# **Changes to MAC Service Interface Affected Flow Control**

Glen Kramer, Teknovus, Inc.  
glen.kramer@teknovus.com

Figure 31B-1—PAUSE Operation Transmit state diagram

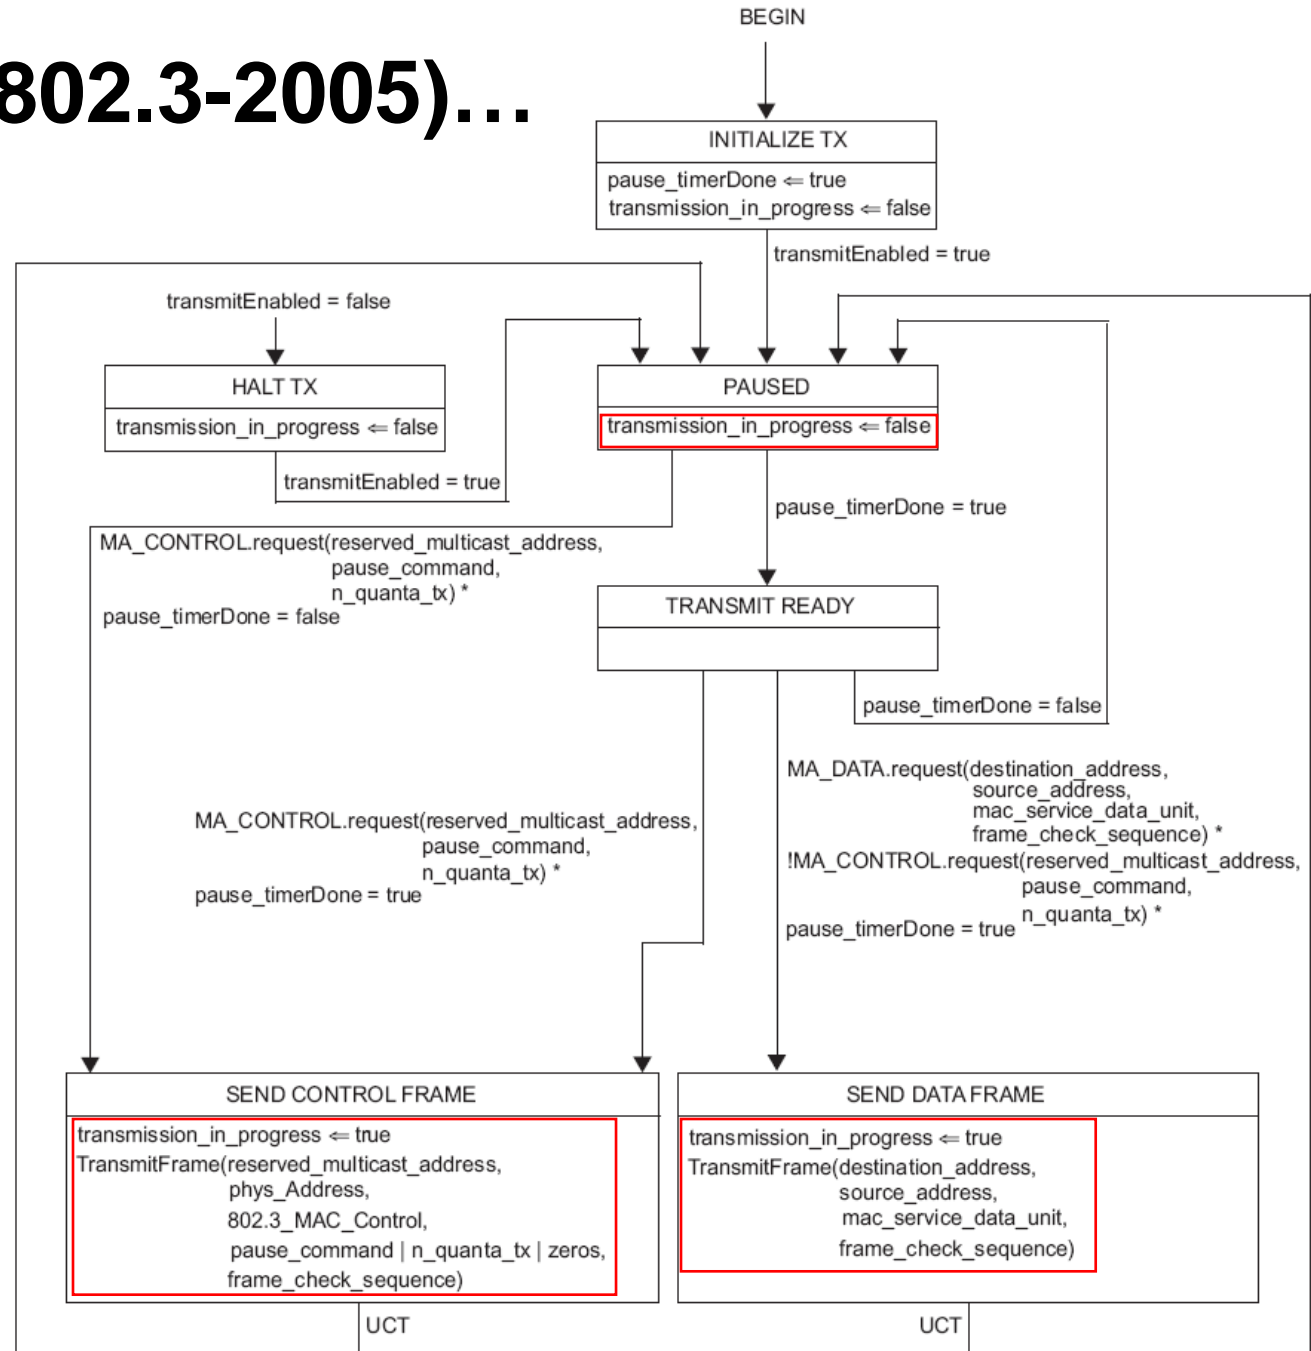
- The PAUSE transmit FSM assumed that call to the TransmitFrame() function only returned after the entire frame got transmitted, **not instantaneously**.
- This ensured that transmit\_in\_progress variable remained true for the entire duration of frame transmission

Figure 31B-1—PAUSE Operation Transmit state diagram

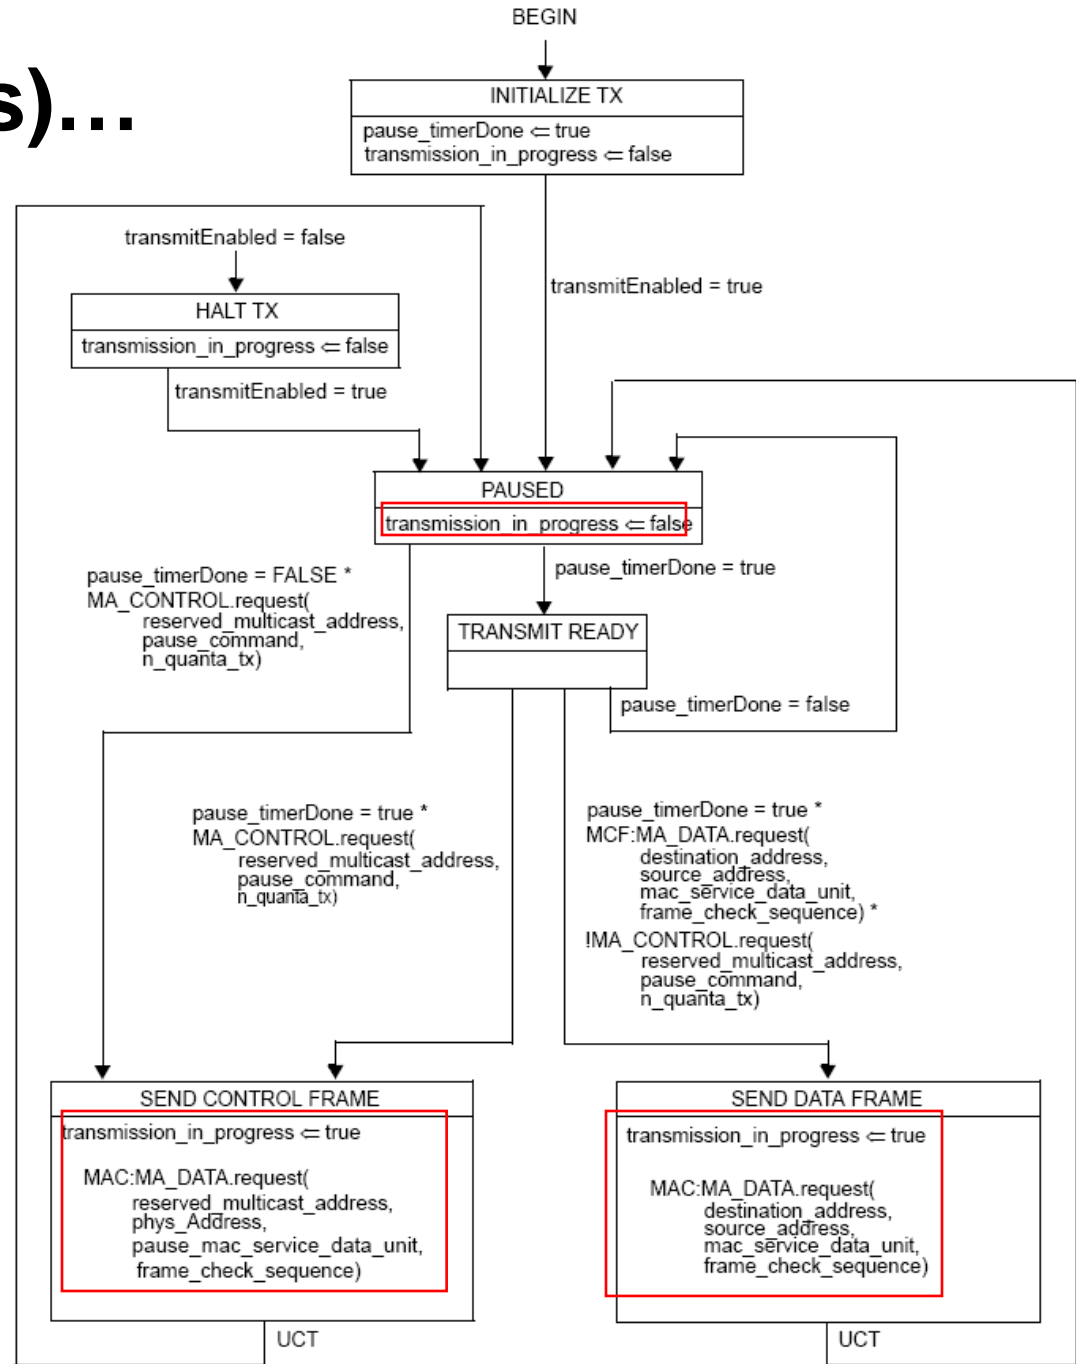
- In states SEND\_CONTROL\_FRAME and SEND\_DATA\_FRAME, the MAC:MA\_DATA.request executes instantaneously and the control passes back to state PAUSED.
- The transmit\_in\_progress is only asserted for an instance and is quickly reset back to false.

- Today, Flow Control is fundamentally broken
- To fix it, either revert to TransmitFrame and document the function blocking behavior (FSM remains in state until the function completes)
- ...Or...
- Add explicit MAC indication to the MAC Client (flow control in this case) that transmission has ended (as shown →)

Figure 31B-2—PAUSE Operation Receive state diagram

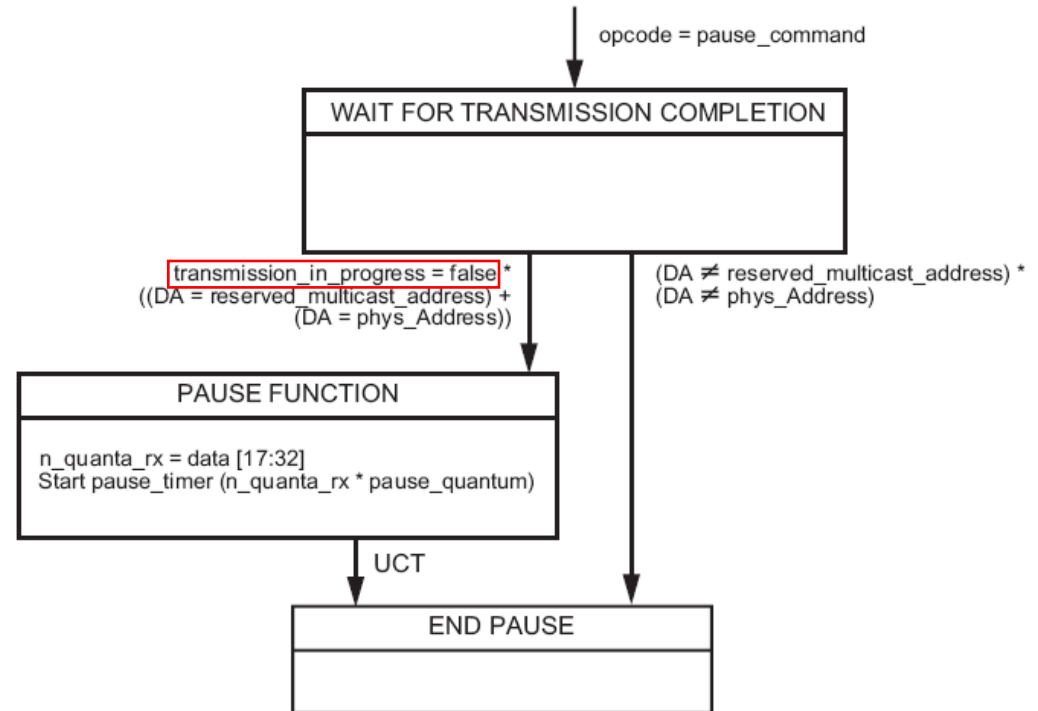
- The transmit\_in\_progress variable is used in the receive state machine to decide when to start the Pause timer (it should not start in the middle of transmitting a frame).

# Disappearing Flow Control Act

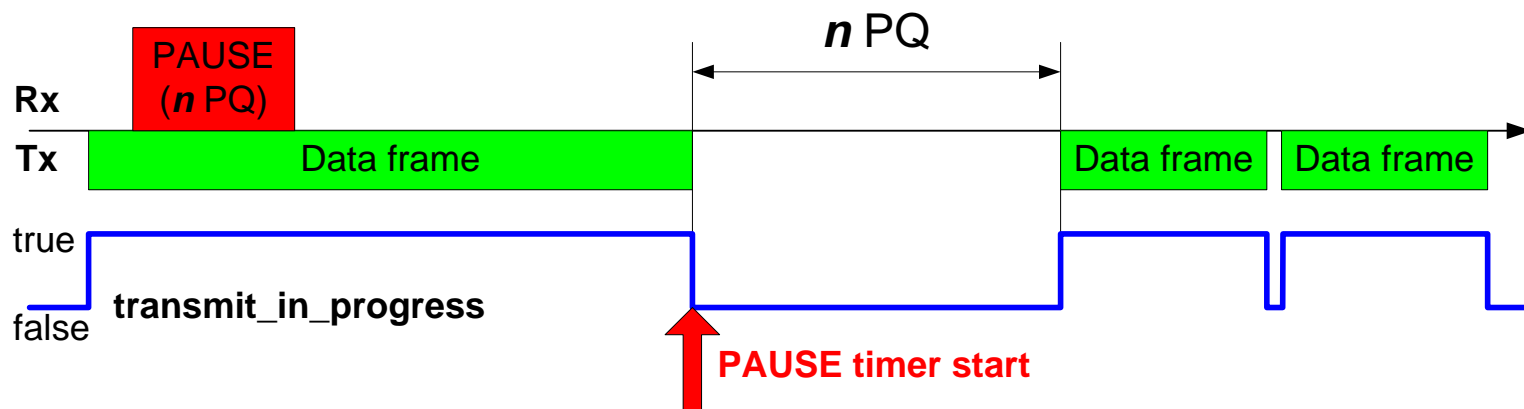
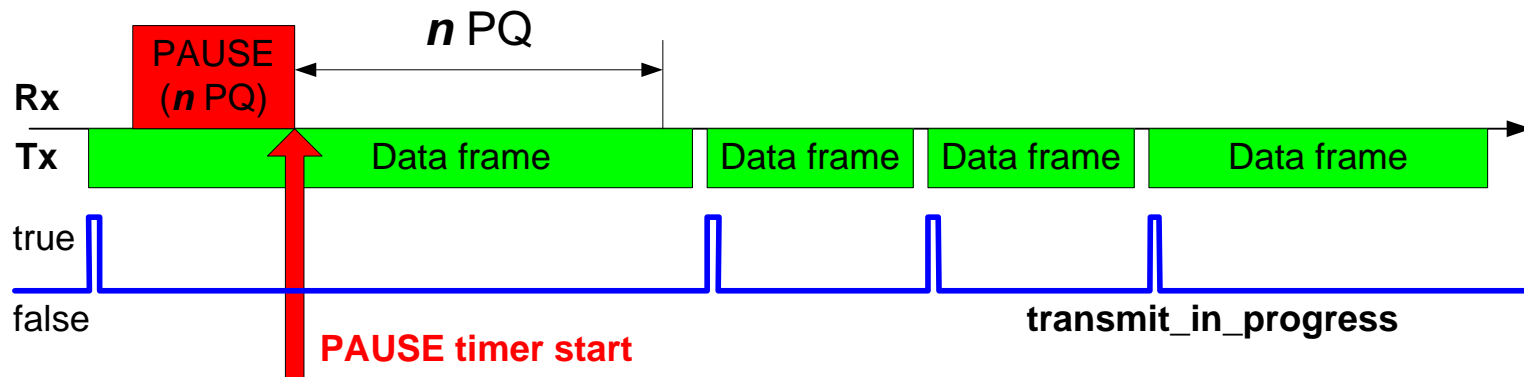
- If PAUSE arrives during a frame transmission and pause\_time is shorter than the remaining frame transmission time, the transmitter **will not pause at all!**
